Bulletin # SR-5R-1309-02

SAFETY BULLETIN

Ride Manufacturer: Dartron	Affected Production Dates: July 2004 – October 2009
Ride Name: Zero Gravity	Affected Serial #'s: 0404125-5R FORWARD
Model #: All

Detail of issue:

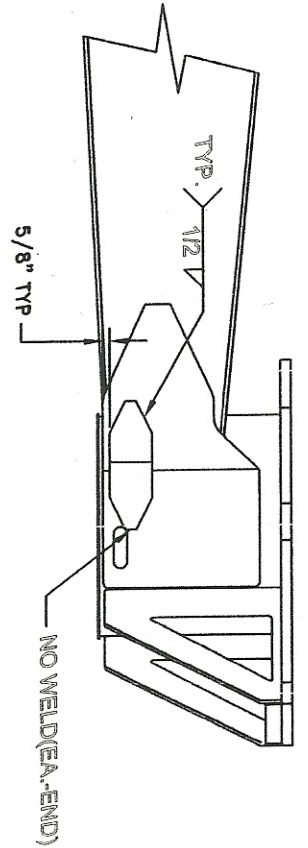
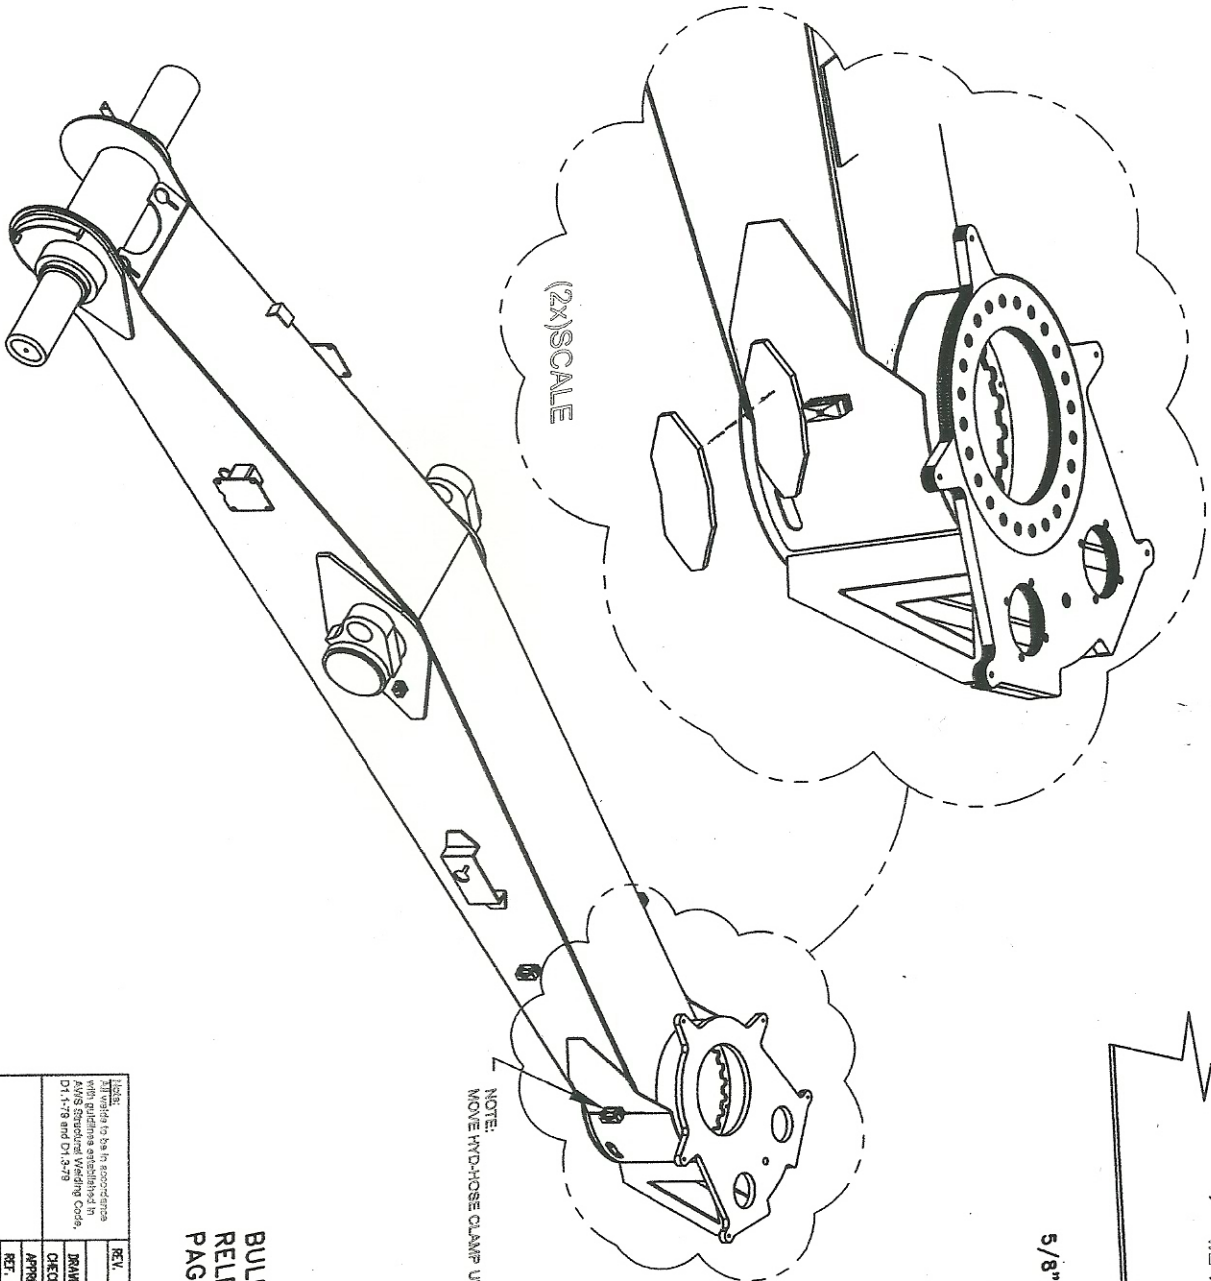
Abstract of Issue: Early production Dartron Industries, Inc. Zero Gravity amusement rides were produced using a thinner material on the boom drum and boom reinforcement plates. Cracking has been discovered in this area. Testing has determined that ALL Zero Gravities may eventually develop cracking in the same area.

Reason for release: To notify all owners, operators and inspectors of a safety concern with the booms on the Zero Gravity. Subsequent testing has determined that a reinforcement plate is required to insure that this area will not develop cracks at a future time. Failure to add these reinforcement plates may eventually result in the boom drum (bearing base) not adequately supporting the center bearing. A failure in this area could result in injuries.

1. No Zero Gravity is to be operated after December 31, 2013 until this Safety Bulletin is complied with.
2. Contact Battech at (503) 362-2341 to arrange purchase of the structural reinforcing plates.
3. A welding technician certified in the F2, F3 and F4 positions or equivalent (see D1.1 section 4 figure 4.3) must perform the welding procedure. This certification can be issued by any State. The attached form will need to be completed by the welder and retained with the ride documentation.
4. Welding to be performed using 7018 stick electrode DC reverse polarity.
5. Prepare the Zero Gravity for the repairs as explained on Page 2.
6. Install the plates as explained on Page 3.
